Treviglio, Friday, September 22, 2017

Bianchi's internal test laboratory has recently detected a possible error on seat clamp assembly of our Aria road bike model.

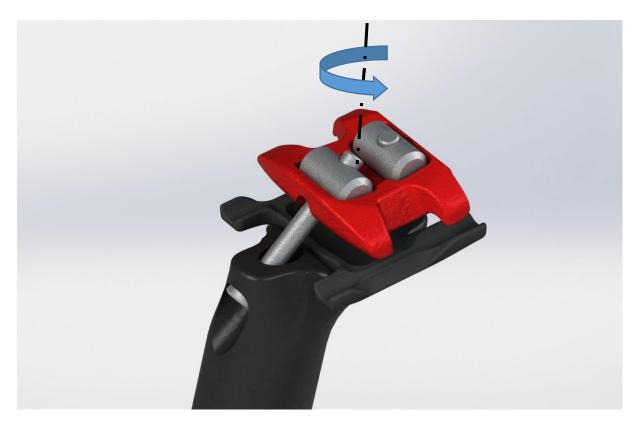
In some samples, the top part of seat clamp could have be installed in reversed position; this issue could compromise the seat clamp functionality making difficult to place the saddle in 0° position and, more important, can lead to a not properly working seat clamp's screws with a dangerous overstress.

In case you find your seat clamp is assembled in wrong position, proceed as follow:

- 1. remove the saddle,
- 2. remove both screw and bottle nut
- 3. rotate the seat clamp top part (red component in picture below) of 180° around a vertical axis
- 4. re-assemble the seat clamp and install the saddle.
- 5. check if the seat clamp is correctly installed (refer to picture above)
